PR/1410/22

Record of Executive Business and Chief Executive's Order

Reg. Reference: SD22A/0357 **Application Date:** 13-Sep-2022
Submission Type: New Application **Registration Date:** 12-Sep-2022

Location: Garters Lane, Saggart, Co. Dublin
Applicant Name: Cape Wrath ULC
Application Type: Permission

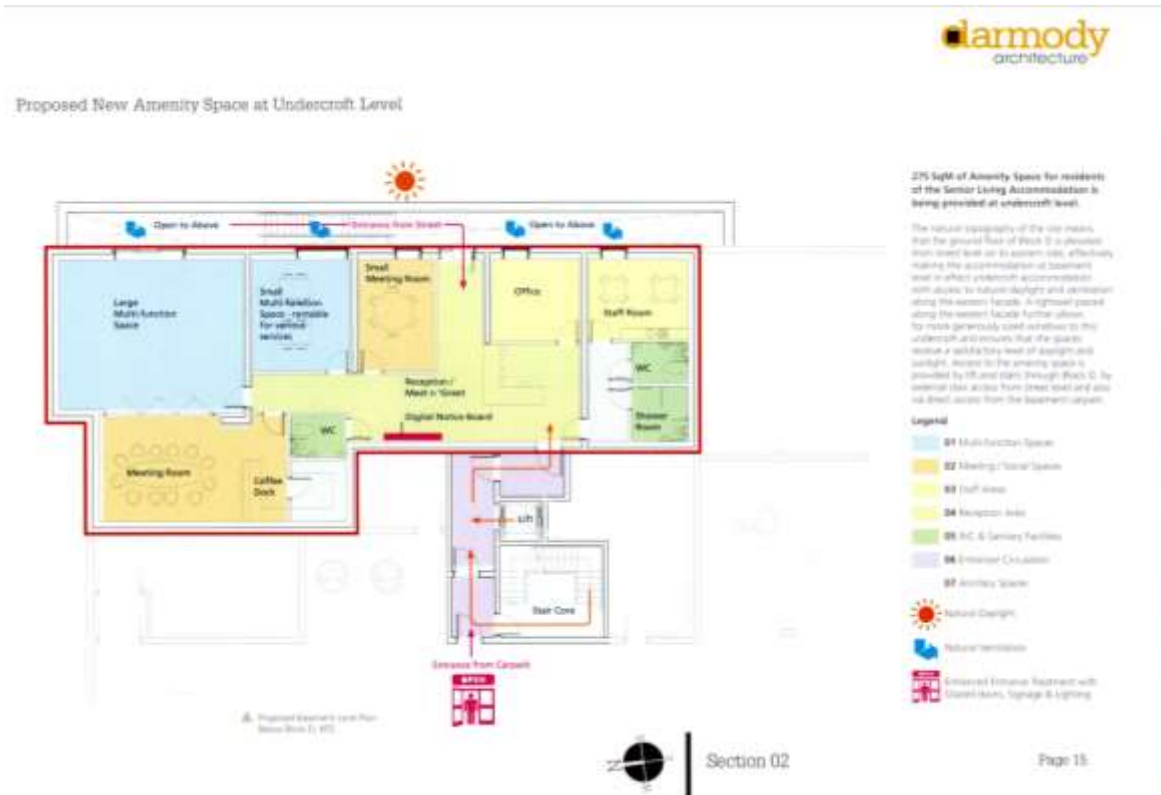
The provision of c. 275sq.m of residential amenity space (incl. reception, office, staff amenities, multi-purpose spaces, meeting rooms and lobbies) at basement level of permitted Block C and D. These changes are identified by the number 06 (proposed basement plan) below and are considered to be broadly acceptable in this instance. It is noted that the topography of the site means that the ground floor of Block D is elevated from street level on its eastern side effectively making the accommodation at basement level in effect undercroft accommodation with access to natural daylight and ventilation along the eastern facade.

Block D East Elevation Changes

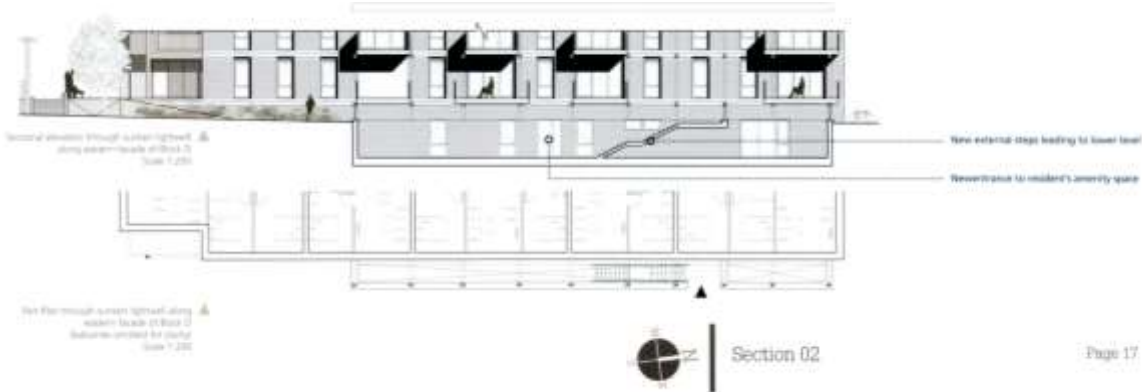
Minor elevation amendments to permitted Block D

The proposal seeks minor elevation amendments to permitted Block D comprising of the provision of a new external stair well to the eastern elevation of Block D providing access from the ground floor level to the basement level. Access to amenity space will be provided by lift and stairs through Block D and by external stair access from street level and also via direct access from the basement car park. This amendment to the proposed SHD is considered to be acceptable.
